# TECHNICAL INFORMATION

No: 76/10/99/NAS  
Ref:  
Issue: 2  
Date: 05/19/99

## Rattle in Right A-pillar

**DISCOVERY Series II (LT) Up to XA224285**

Figure 1

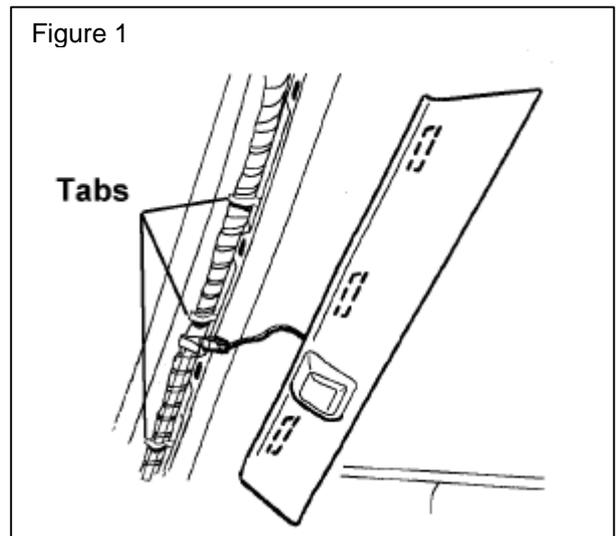
Customers may complain of a tapping or rattle in the right "A-post" area. The rattle may be the result of wiring harness contact with the pillar trim.

1. Carefully release the clips securing the right hand "A-post" trim. (Figure 1)
2. Disconnect the multi-plug from the speaker.
3. Remove right hand "A-post" trim.
4. Release the body tags securing the coaxial cable.

1. Twist foam tape around the cable from top to bottom.
2. Reposition cable and secure with body locating tabs.
3. Connect the multi-plug to the speaker.
4. Locate "A-post" trim and snap into position.
